Re: Rosa 31B Non-Standard Dakota Location

To summarize: Williams is still requesting administrative approval for a non-standard Dakota location for the Rosa 31B at it's current proposed location (section 17 31N 5W - 570' fnl & 515' fwl) based on:

Re: Request for Administrative approval for Non-Standard Dakota Location Rosa Unit 31B (Sec 17/T31N/R5W, 570' fnl & 515' fwl, Rio Arriba County, New Mexico)

USGS Aerial Photograph

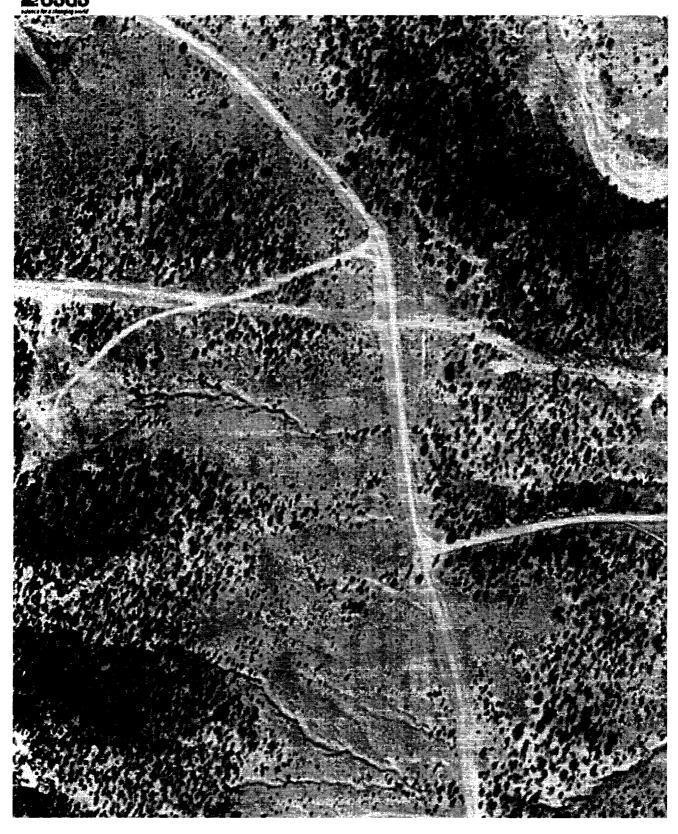
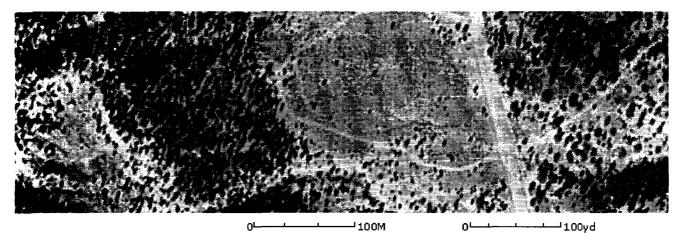
Mike this is a Terraserver air photo view of the area around the RU #31B to go with the email critique I am sending separately.

RU #31B, This is a reasonable fit for the elliptical drainage pattern here in the Mesaverde, but I would question whether the pattern could not have been as well matched with a location south and a little road shown on the topo sheet included in the application. I am sending a separate air photo location and surrounding area.
